Town of Hilton Head Island Design Review Board Regular Meeting

January 24, 2017

RE: Port Royal Tennis Facility Plans Approval Board Final DRB Approval

DESIGN TEAM/DRB COMMENT SHEET

Sheet Title:
 Site Plan
 Job Number:
 201609-02
 Date:
 Drawn:
 Approved:
 Revisions:

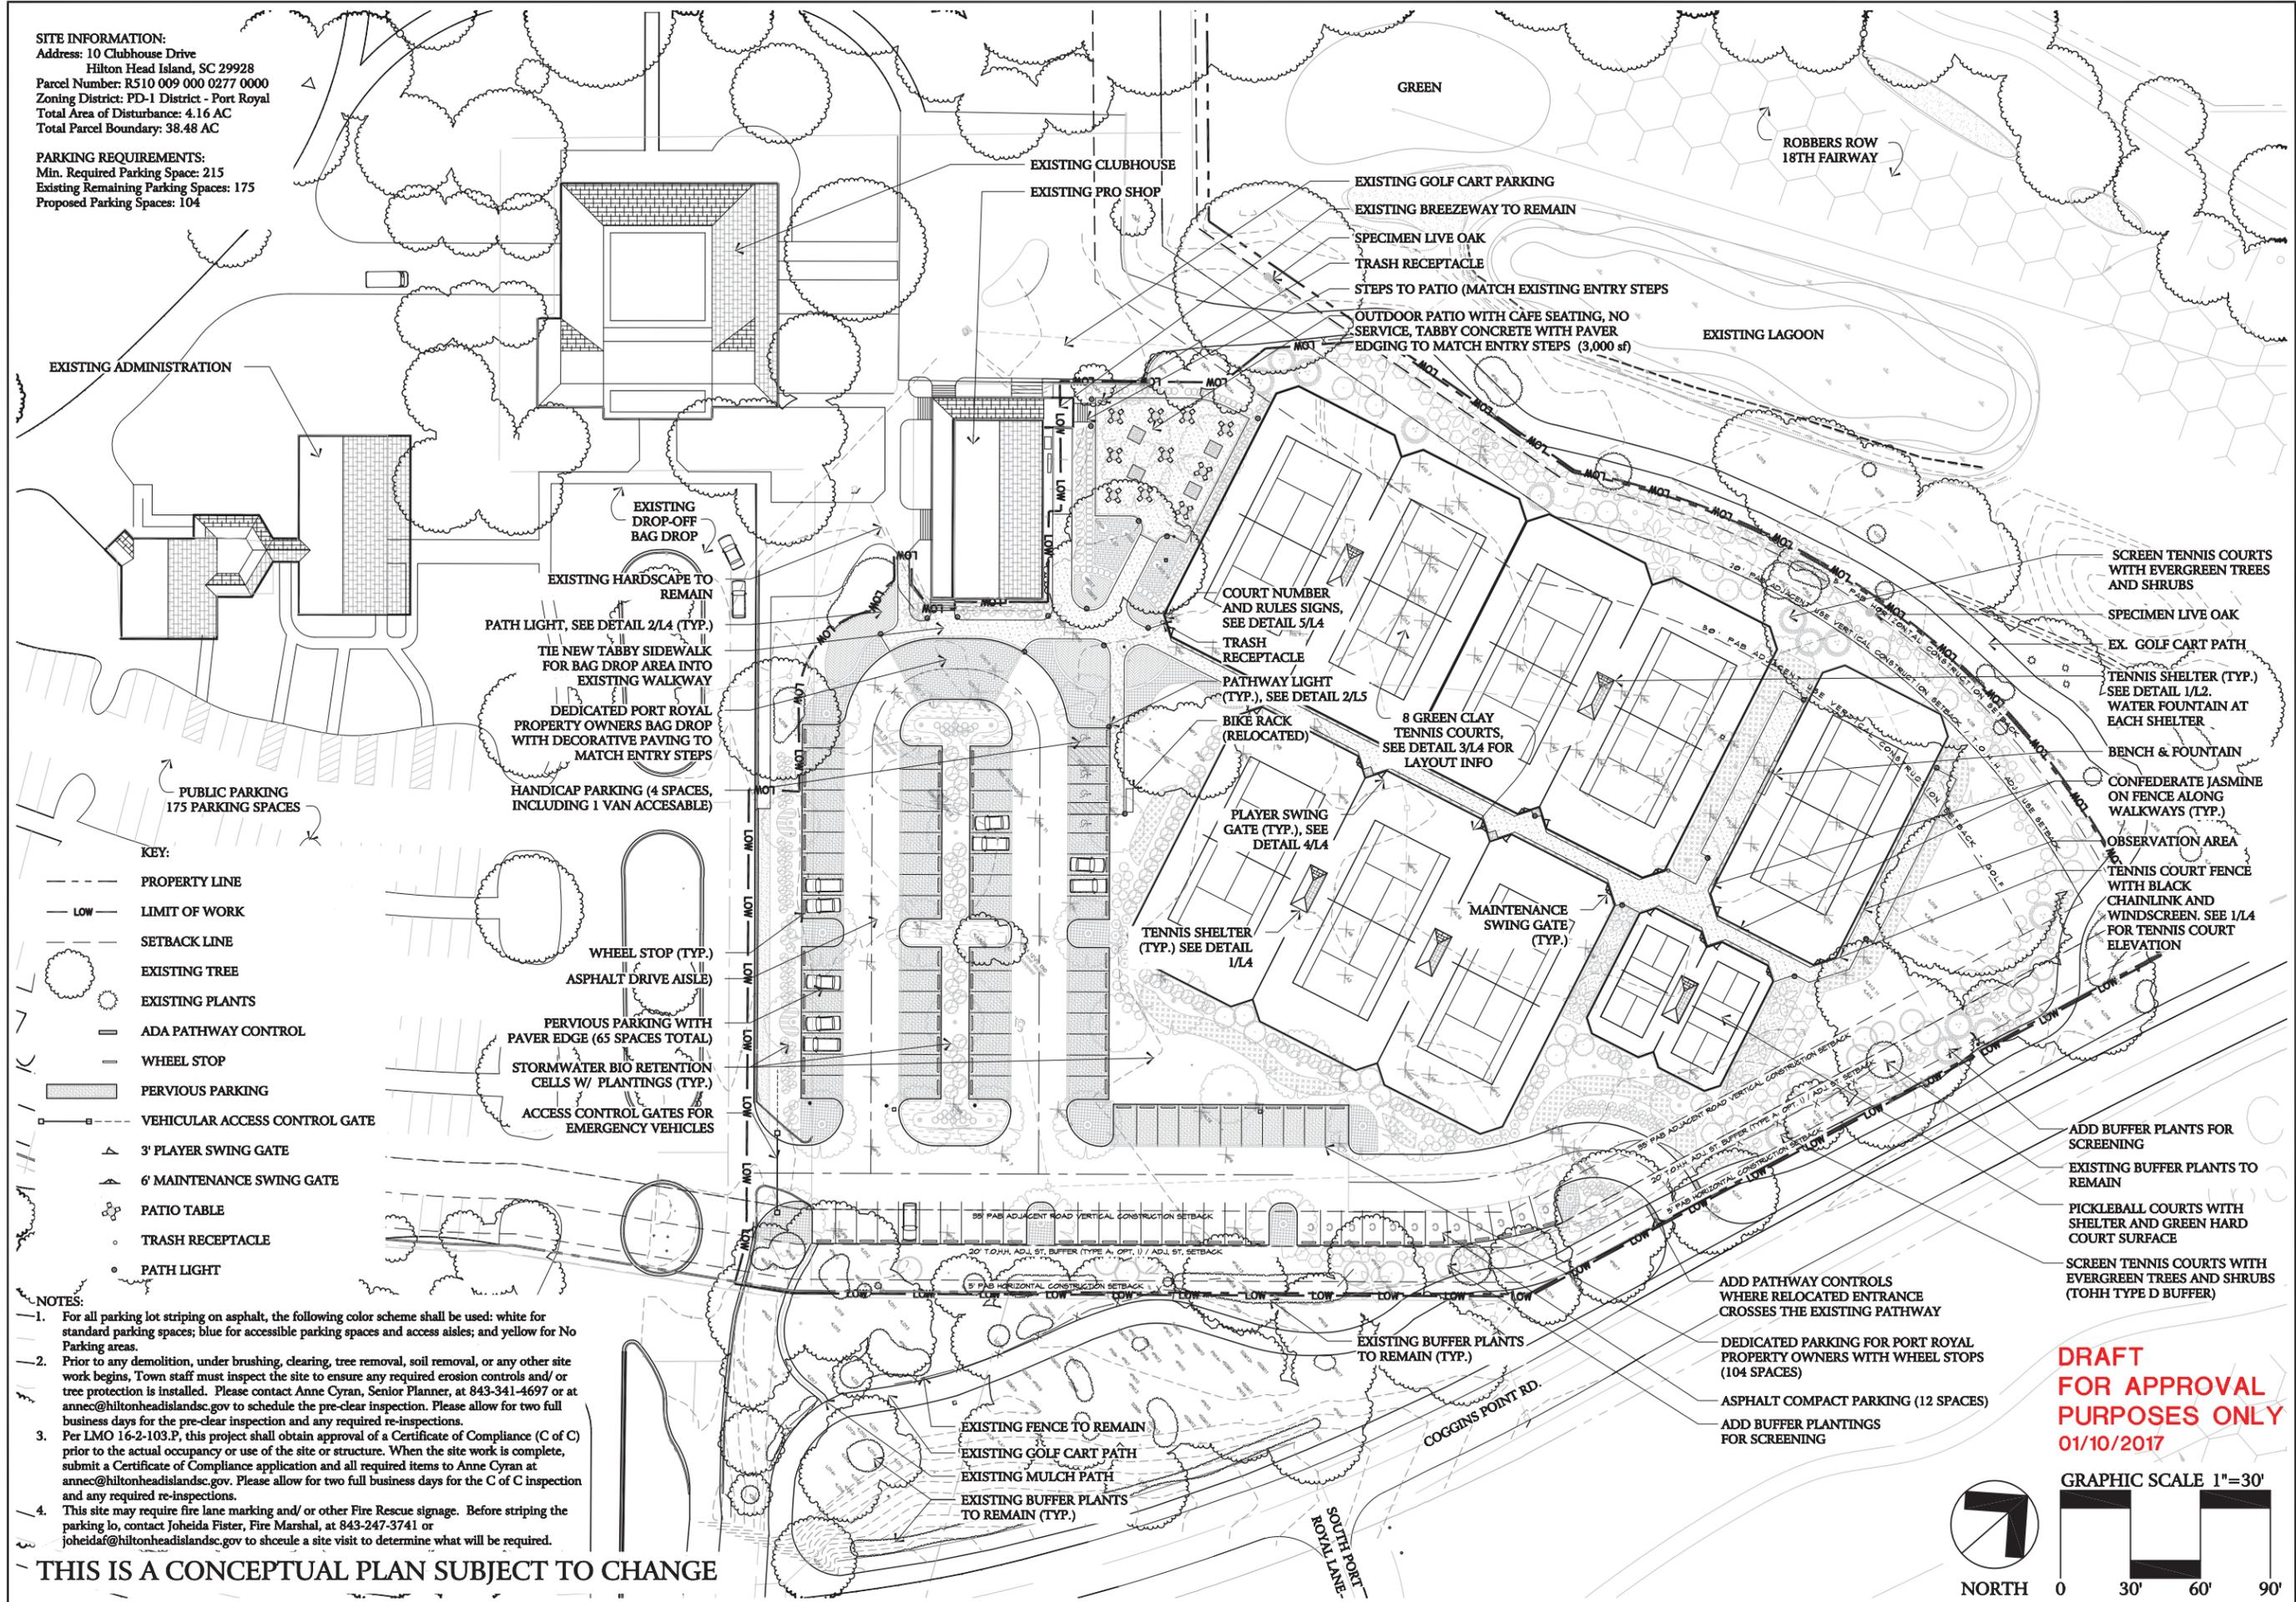
1. The tennis court orientation is 22 degrees west of north per the International Tennis Federation Guidelines.
2. The proposed maintenance building has been deleted from the plans to allow more buffer between the road and the tennis courts.

LIGHTING PROPOSAL FOR
PORT ROYAL TENNIS
COGGINS POINT ROAD
TOWN OF HILTON HEAD
BEAUFORT COUNTY, SOUTH CAROLINA

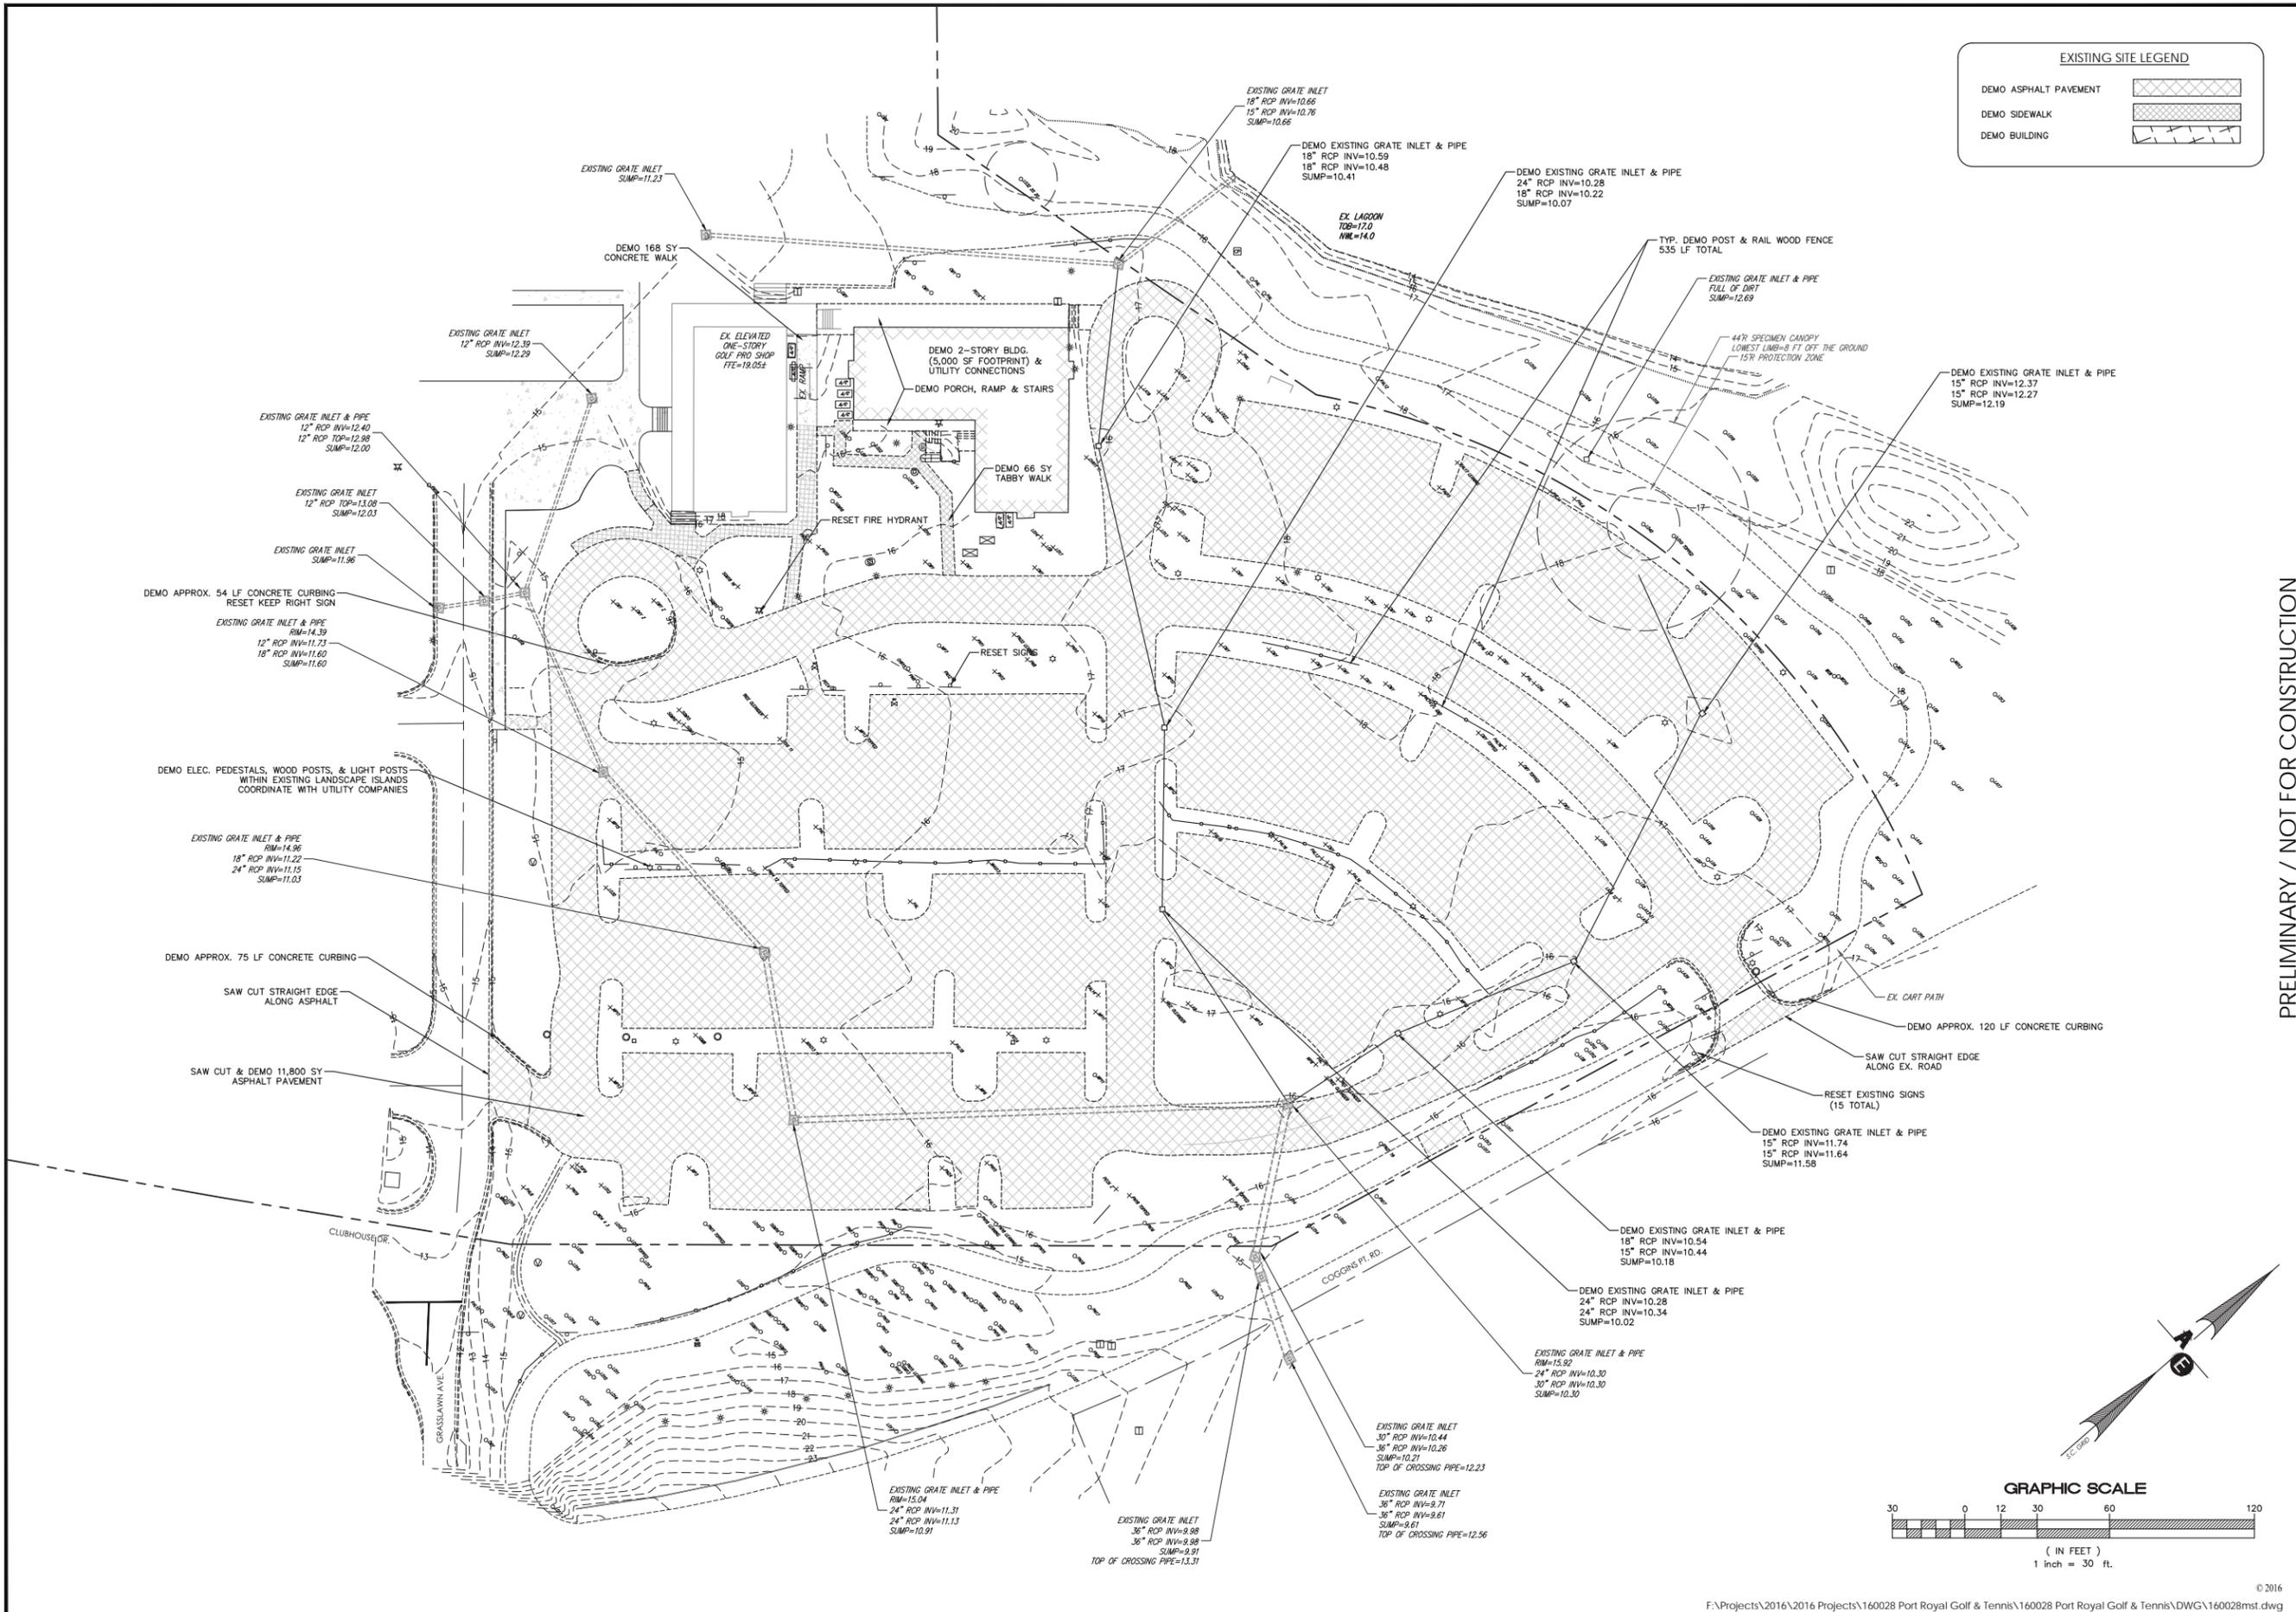
11. The Lighting Plan average exceeds the level listed in Table 16-5-108.D in the LMO. Adjust the Lighting Plan to meet this requirement.

REAR ELEVATION

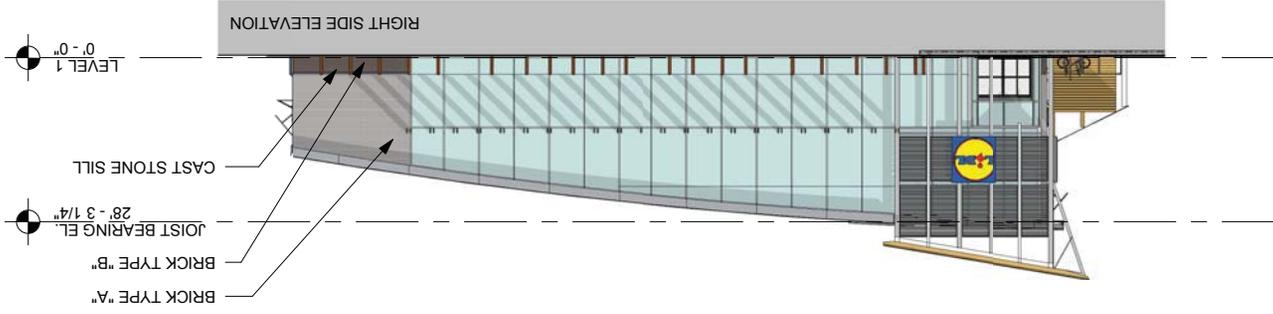
1. The PVC soffit panels should be a more weathered color.
2. Specify the color of the mechanical equipment screening at the rear of the building.
3. Clarify where "Tabby Stucco Finish B – Roycroft Pewter" is on the building elevations.
